CRMC DECISION WORKSHEET

2025-11-063

STATE OF RHODE ISLAND
COASTAL RESOURCES MANAGEMENT COUNCIL
STAFF REPORT TO THE COUNCIL

Applicant's Name:	Geoffrey Van Gorkom
CRMC File Number:	2025-11-063
Project:	Construct and maintain a residential boating facility consisting of a 4x76' fixed pier, a 3x24 ramp and an 8x18.75' float. The facility shall extend 90' beyond Mean Low Water (MLW) at a depth of approximately 2 feet, requiring a 40' Variance to Section 1.3.1(D)(11)(l).
Location:	305 Riverside Street; Portsmouth: Plat(s): 15; Lot(s): 47
Water Type/Name:	Type 2, Low Intensity Use/Bluebell Cove
Coastal Feature:	Coastal Bluff with Stone wall
Plans Reviewed:	"Construction of Timber Dock, Gangway & Floater", 7 pages in total, sheet 1-5 and 7 dated 11/17/2025, and sheet 6 dated 10/20/2025 by Mount Hope Engineering, Inc

Google Earth Imagery March 2025, with approximate length of proposed facility in yellow

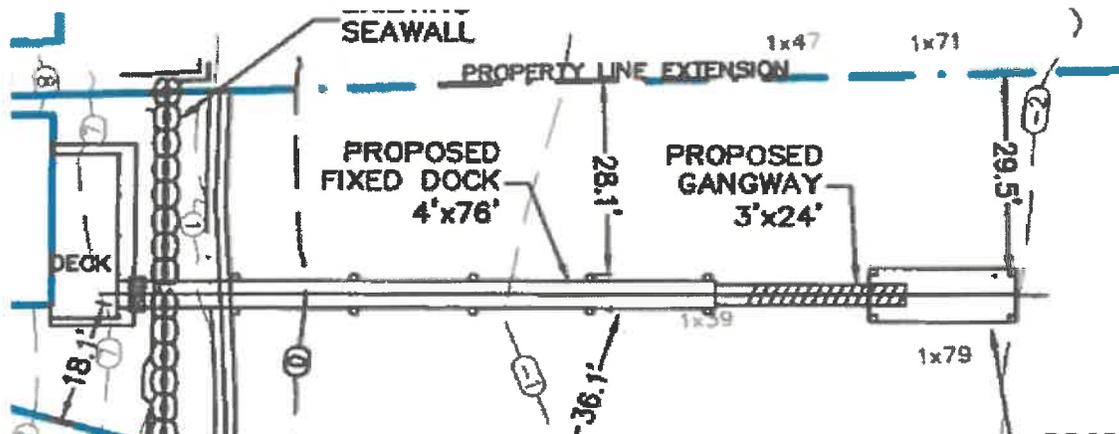
Staff has reviewed the nearby facilities and found the following:

315 Riverside Ave: (Under construction in below image), approved by 2022-10-022, extending to 75’ beyond MLW for less than 2’ depth and a total length of approximately 91’.

319 Riverside Ave: approved by 2022-06-021, extending to 75’ beyond MLW for 4’ depth and a total length of approximately 100’.

327 Riverside Ave: approved by 2018-06-009, extending to 75’ beyond MLW for a minimum water depth of 1.5’ and a total length of approximately 100’.

303 Riverside Ave: (to the right of the proposed facility) approved by 1983-12-013, extending to approximately 95’ beyond MLW for less than 3’ depth and a total length of approximately 125’.

In the image above, the yellow line at the subject lot is approximately 108' total length, showing the facility is similar to the two most recent facilities approved.

It is the opinion of reviewing staff that the applicant has met the burdens of proof for granting of a Variance.
